SUBJECT: REQUEST FOR ADDITIONAL INFORMATION LETTER NO. 11 -  
AP1000 DESIGN CERTIFICATION REVIEW (TAC NO. MB4683)

Request for Additional Information (RAI)  
AP1000 Standard Design Certification  
Series 440 - Reactor Systems  
Series 451 - Meteorology  
Series 470 - Radiological Impact  
Series 720 - Reliability and Risk Assessment

Figure 1. Branch line quality for liquid level at main pipe midplane for ATLATS and AP1000.

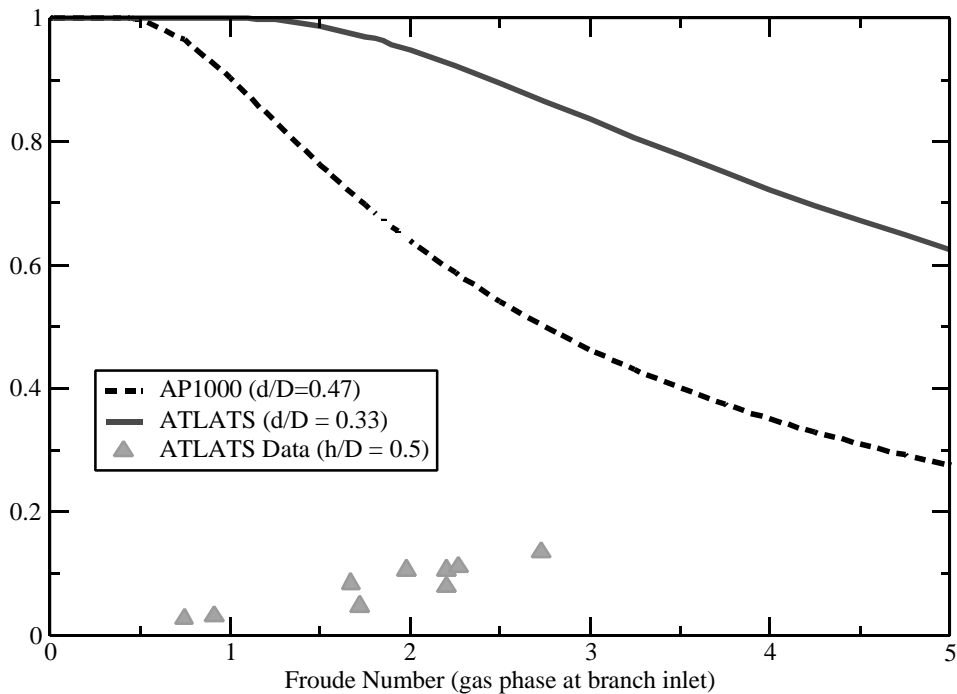
The coefficients used in WCOBRA/TRAC-AP are those of Anderson and Benedetti. The TRAC-M code also uses Equations (1) and (2) but with the coefficients by Smoglie. However, the coefficients by Smoglie and by Anderson and Benedetti are nearly identical, and the WCOBRA/TRAC-AP and TRAC-M models generate the same results. Figure 1 shows the predicted variation of branch line quality as a function of the branch line Froude number assuming the liquid level in the main pipe is at the midplane ( $h/D = 0.5$ ) for two cases in which the ratio of the branch line to main pipe diameter is large compared to the database used to determine the coefficients in Table 1. ATLATS is a separate effects test facility with dimensions scaled to those of the AP600 that was used to investigate phase separation at the junction between a small branch line and a main pipe. The ratio of the branch line to the main pipe in ATLATS is  $d/D = 0.33$ , which is less than the AP1000 ratio of  $d/D = 0.47$ . Calculations for both the ATLATS test facility geometry and the AP1000 hot leg and ADS-4 junction are also shown. As the ratio ( $d/D$ ) increases, the model predicts lower branch line qualities. However, in neither case are the predicted branch line qualities in reasonable agreement with the experimental data shown in Figure 1. These data are from ATLATS tests, with the equilibrium level at approximately  $h/D = 0.5$ , consistent with the calculations.

The comparison suggests that the model and coefficients of Equations (1) and (2) and Table 1, grossly overpredict the ADS-4 quality for conditions expected in the AP1000. Please provide suitable justification for Equations (1) and (2) and their coefficients for the large  $d/D$  ratios in the AP1000 design. Provide justification that the phase separation equations used in the WCOBRA/TRAC-AP code are appropriate for the AP1000 ADS-4 analysis in light of these data.

Figure 2. Variation in Branch Line Quality of Entrainment Onset Correlations in Westinghouse Sensitivity Study.

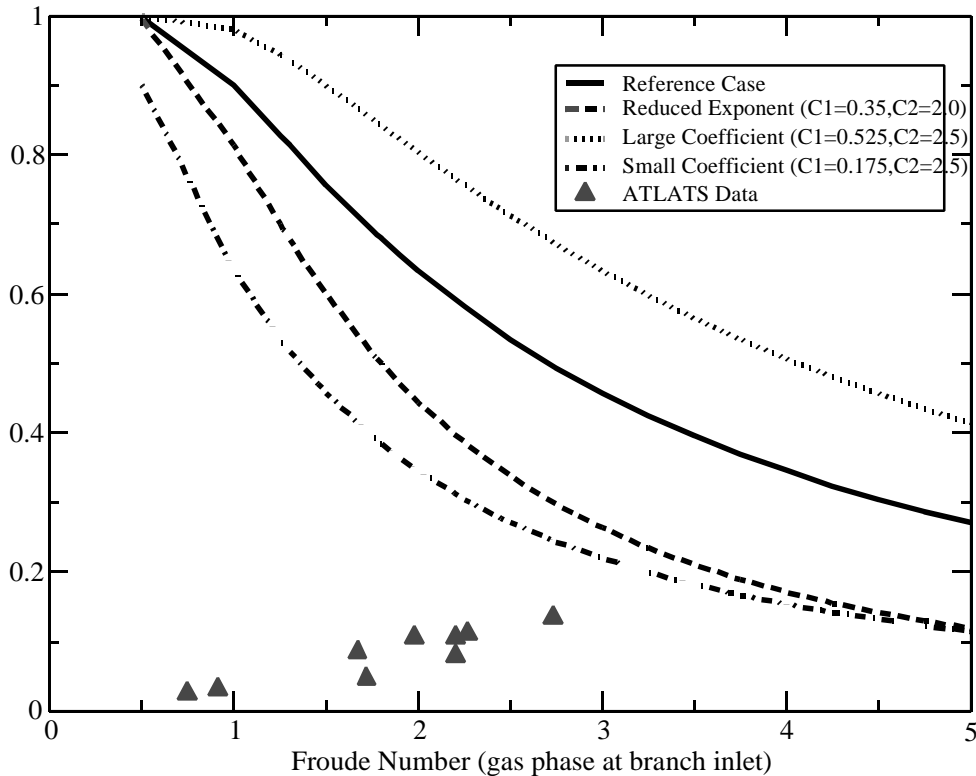
(c) Provide justification that the variation of the Top Offtake Orientation model in Section A.4.4 is sufficient to account for inaccuracies in the model when compared to experimental data. Figure 2 shows the variations considered in the sensitivity study. When data from the ATLATS tests are compared to the correlation and its variations in the sensitivity study, it can be seen

that the branch line quality is grossly over-estimated for the two cases in which the offtake quality was reduced compared to the Reference. For example, at Froude numbers less than one the data suggests very low branch line quality while the correlation and its variations predict very high quality ( $x > 0.75$ ).
